(A). 05/ 1998 - AS PUILT; REBUILT & ADDED E/P L.T. FOR S.B. MD 191; AW-2775185
W.M. | D.J.D. | D.A.Z. | B.A.K. | | T.H.
[B]. 04/ 1999 - REVISED PLANS FOR NEW SIGNAL POLE PLACEMENT & ADDITIONAL SIGNAL POLE; AW-2775183

MARYLAND DOT - STATE HIGHWAY ADMINISTRATION
Office of Traffic & Safety
TRAFFIC ENGINEERING DESIGN DIVISION

MD 191 (BRADLEY BLVD.) & HUNTINGTON PARKWAY

REVISED WIRING DIAGRAM

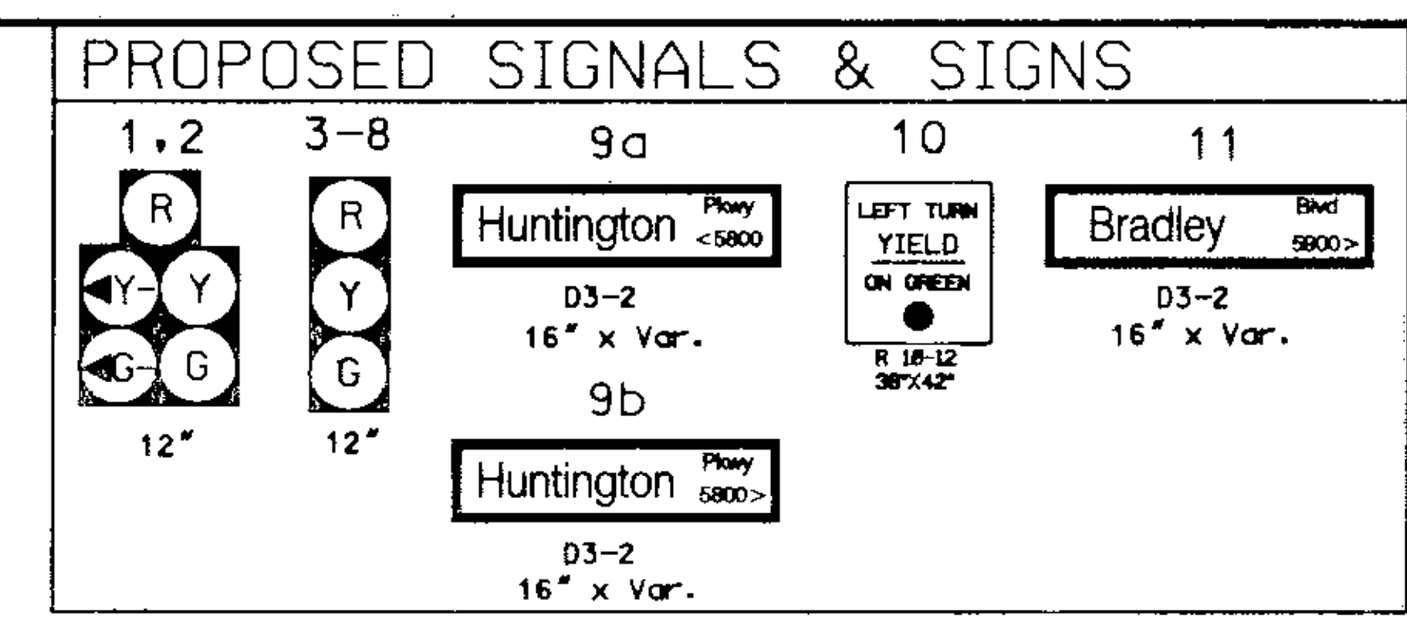
A-E = 7 CONDUCTOR CABLE (NO. 14 AWG)
F-H = 5 CONDUCTOR CABLE (NO. 14 AWG)
I-L = 2 CONDUCTOR (ALUMIMUM SHIELDED) CABLE (NO. 14 AWG)
M = 1 CONDUCTOR CABLE (NO. 4 AWG) - (3 TIMES) - FOR SERVICE
N-Q = NO. 6 AWG STRANDED BARE COPPER GROUND WIRE
R = 2 CONDUCTOR CABLE (NO. 14 AWG)
S = EXISTING INTERCONNECT CABLE
T = PROPOSED TELEPHONE DROP
U = PROPOSED SERVICE FEED
LW = LOOP WIRE

CONSTRUCTION DETAILS (REVISED)

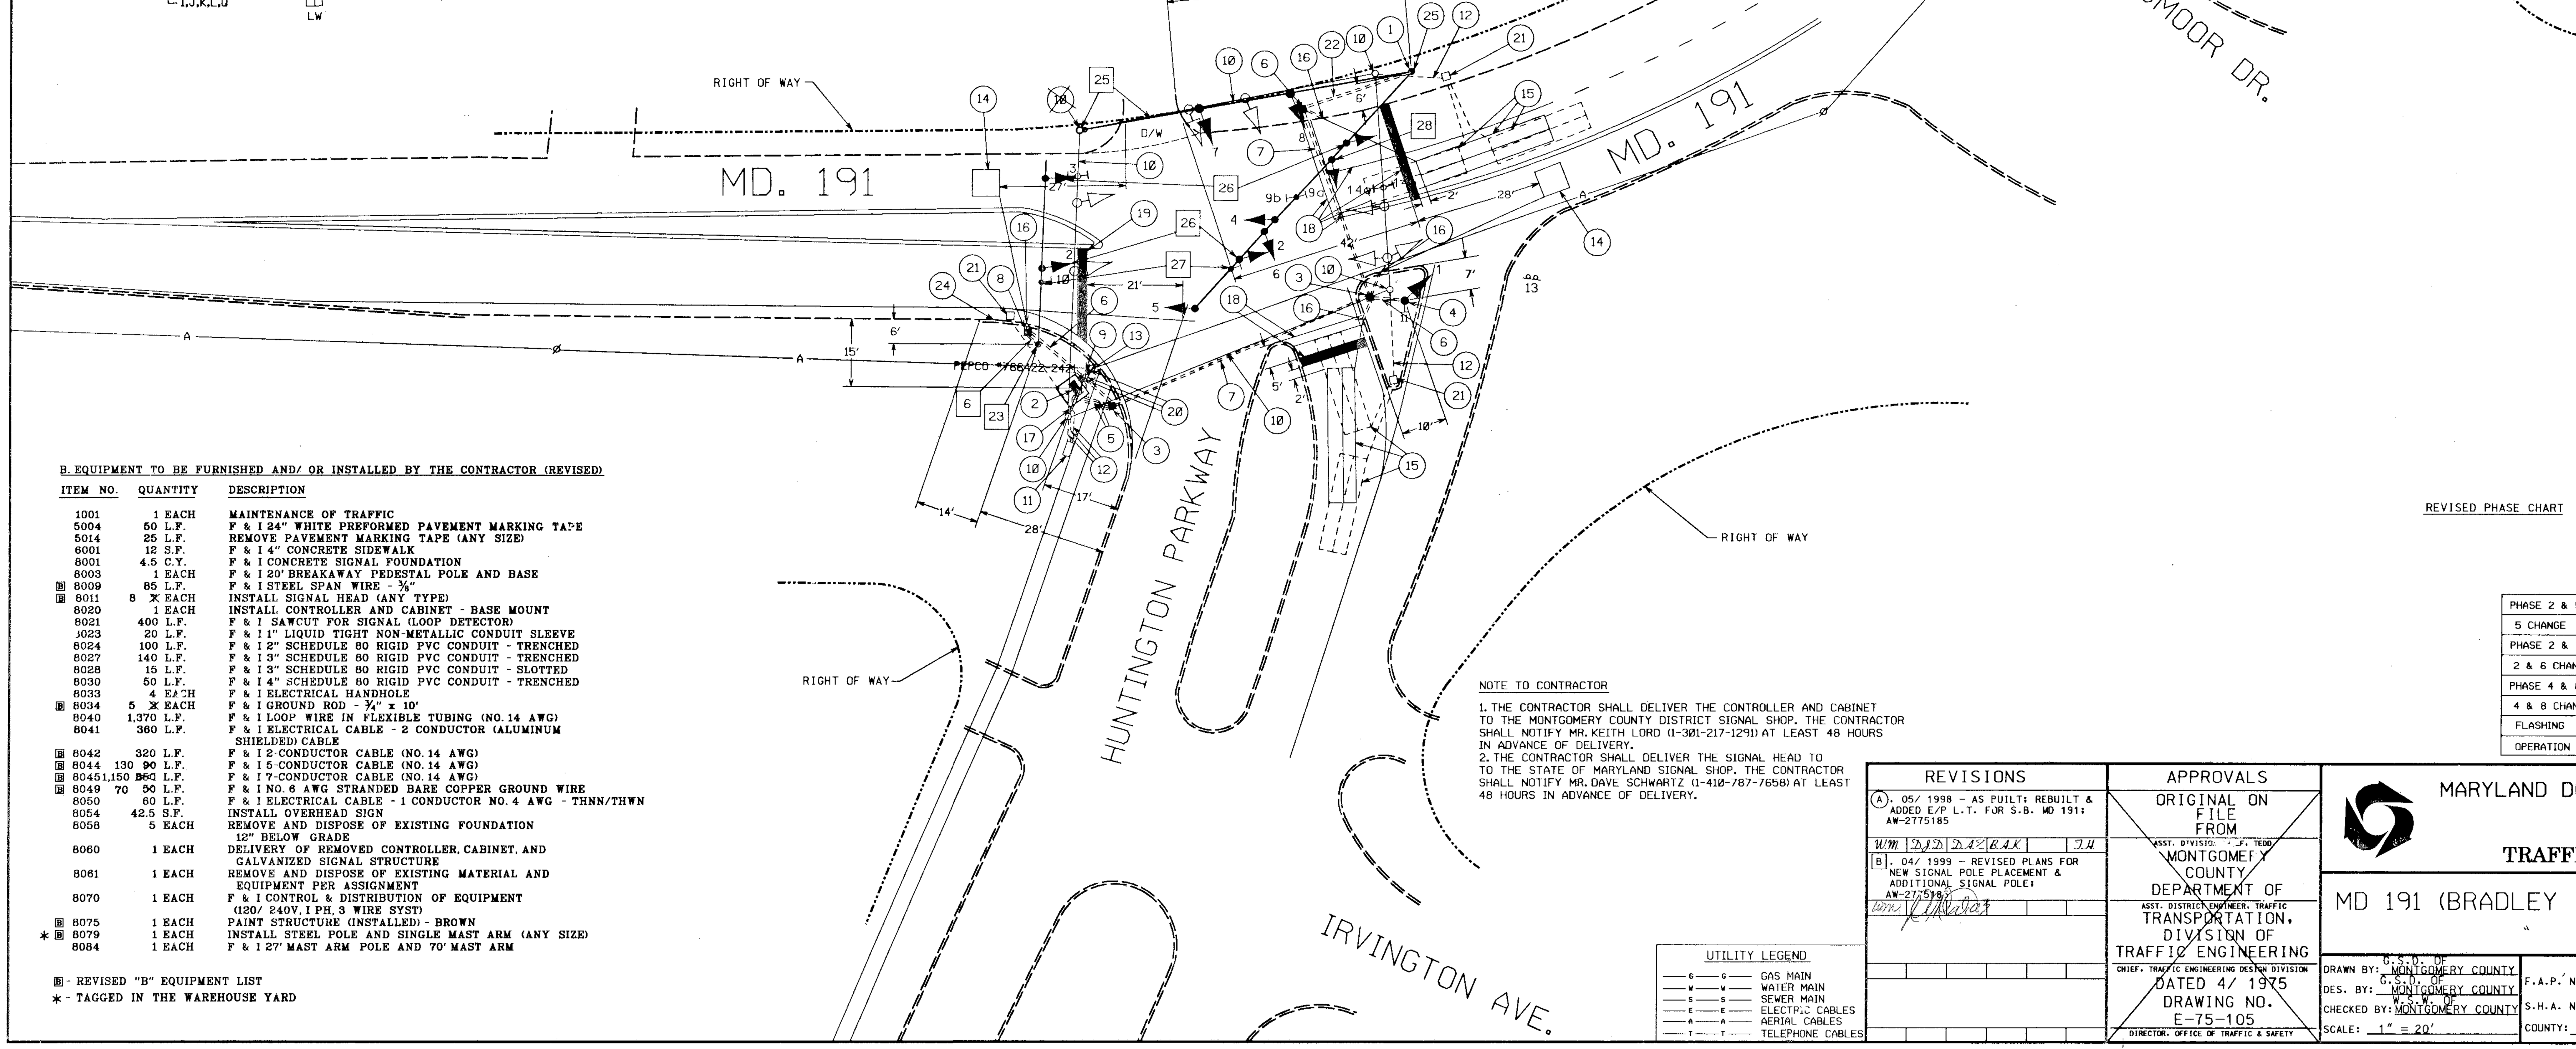
B 1. INSTALL 27' MAST ARM POLE WITH 70' MAST ARM, PROPOSED SIGNAL HEADS (3), SIGNS (2), FOUNDATION, GROUT, AND 3" PVC SCHEDULE 80 CONDUIT BEND.
2. INSTALL THE EIGHT PHASE CONTROLLER HOUSED IN A BASE MOUNTED CABINET, TWO (2) 4" SCHEDULE 80 PVC CONDUIT BENDS, 3" PVC SCHEDULE 80 BEND, FOUNDATION, GROUT, 2" PVC SCHEDULE 80 CONDUIT BENDS, AND 3' x 4' CONCRETE PAD.

21. REMOVE THE EXISTING HANDHOLE. FILL THE HOLE WITH THE APPROPRIATE MATERIAL.
22. INSTALL PROPOSED 3" PVC SCHEDULE 80 CONDUIT - TRENCHED.
* B 23. INSTALL 21' MAST ARM POLE (CUT DOWN FROM 27') WITH 38' MAST ARM, PROPOSED SIGNAL HEADS (2), FOUNDATION, GROUT, AND 2" PVC SCHEDULE 80 CONDUIT BEND.
B 24. INSTALL THE PROPOSED CURB AND GUTTER.
B 25. INSTALL THE PROPOSED 3/8" SPAN WIRE FROM EXISTING POLE TO PROPOSED MAST ARM POLE WITH PROPOSED SIGNAL HEADS (2).
B 26. REMOVE THE PROPOSED MAST ARM SIGNAL HEAD FROM THE PROPOSED 70' MAST ARM, AND INSTALL THIS SIGNAL HEAD ON THE PROPOSED 38' MAST ARM.
B 27. REMOVE THE PROPOSED R10-12 SIGN FROM THE PROPOSED 70' MAST ARM, AND AND INSTALL THIS R10-12 SIGN ON THE PROPOSED 38' MAST ARM.
B 28. REMOVE THE PROPOSED MAST ARM SIGNAL HEAD FROM THE PROPOSED 70' MAST ARM, AND RETURN THIS SIGNAL HEAD TO MR. DAVE SCHWARTZ OF THE SHA SIGNAL SHOP.
B 29. PAINT THE EXISTING POLE BROWN.

B - REVISED CONSTRUCTION DETAILS
* - TAGGED IN THE WAREHOUSE YARD
